SUNDRY NOTICES AND REPORTS ON WELLS

Alkali Federal Com. #11

Yates Petroleum respectfully requests that a variance be granted to the stipulation in the APD that requires cement for the 8 5/8" intermediate casing (if set) to be circulated to surface. The 8 5/8" casing is set strictly to case off lost circulation. Cementing with a low volume of cement (250-300 sx) allows for a good cement job at the shoe (which is set in competent rock beneath the loss zone), which after set allows for the continuation of drilling without lost circulation. We see no need to circulate the string to surface, as there are no fresh water or oil or gas zones in the intermediate hole, just a potential lost circulation zone. If the lost circulation zone is not encountered cement is not required to be placed over this interval when cementing production casing. In short, we would like to cement the intermediate casing with 250 sx class C cement, estimated TOC is 950'. We also would like to change the 4 1/2" 11.6# J-55 ST&C casing to 4 1/2" 10.5# J-55 LT&C casing. Please see attached wellbore schematics for pictorial representation of this sundry notice. Sincerely,

Typical North Pecos Slope well where lost circulation was encountered from 900'-1,600'

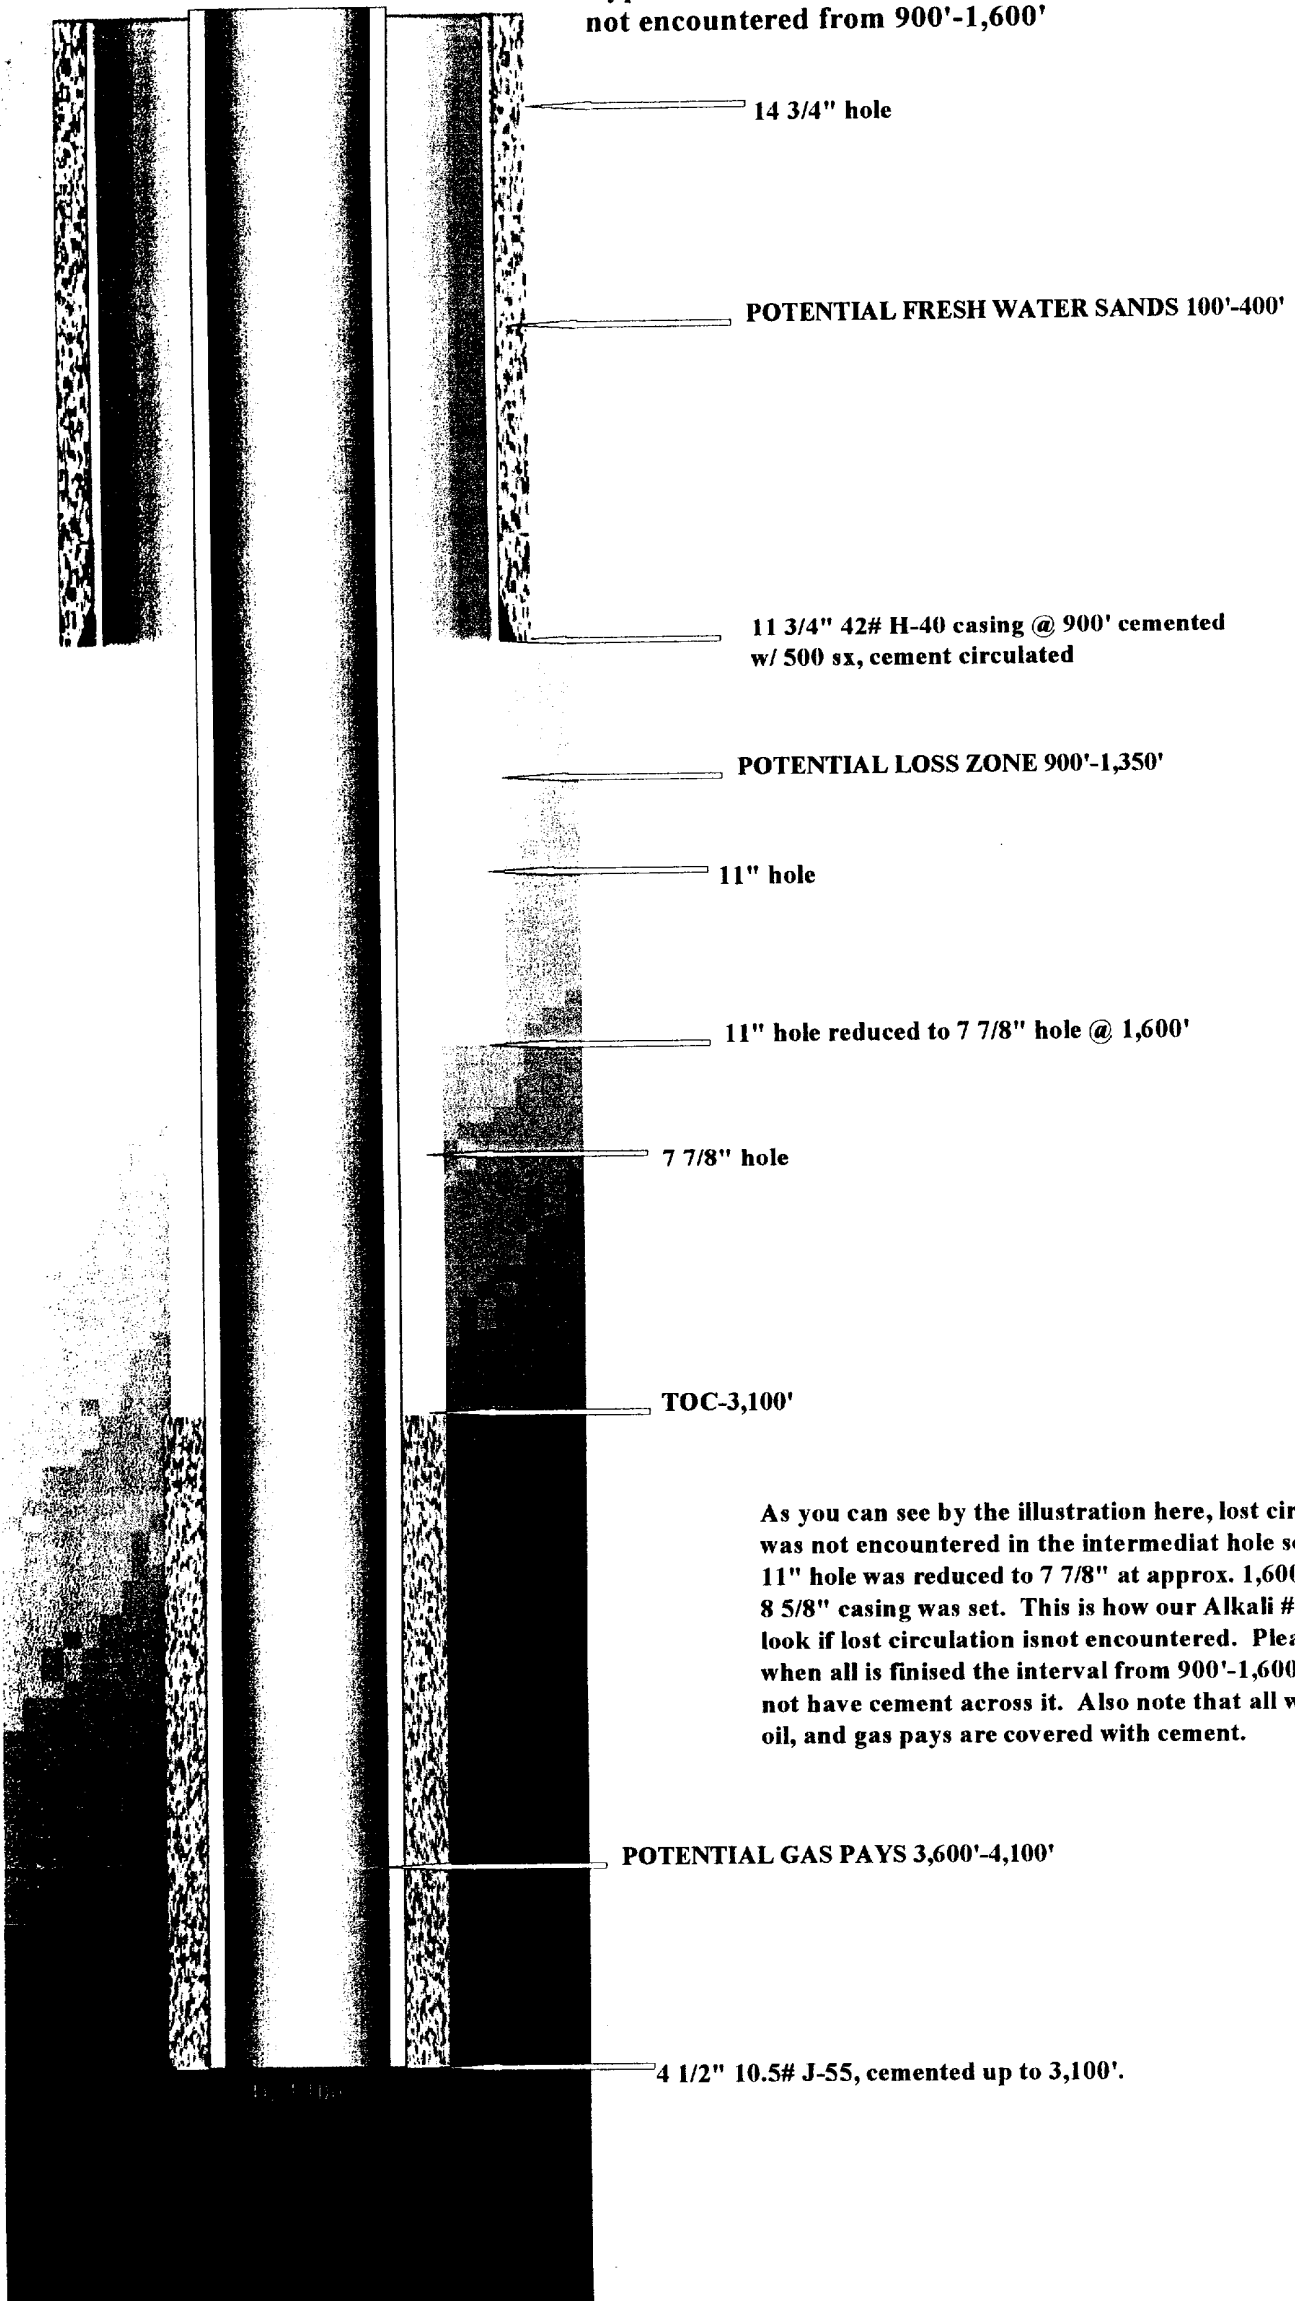
As you can see by the illustration here, lost circulation was encountered in the intermediate hole and cased off with 8 5/8" casing. As in the other wellbore sketch all critical zones (water, oil, and gas) still have cement covering them, thus there is clearly no real need to cement the 8 5/8" casing to surface. It is set just to case off the loss zone and simplify drilling. Further, due to the loss zone remedial cementing would probably be required. This is difficult because 1" tubing is hard to fit between the 11 3/4" and 8 5/8" casing strings. If perforations are used to bring cement to surface the burst integrity of the 8 5/8" casing would be affected.
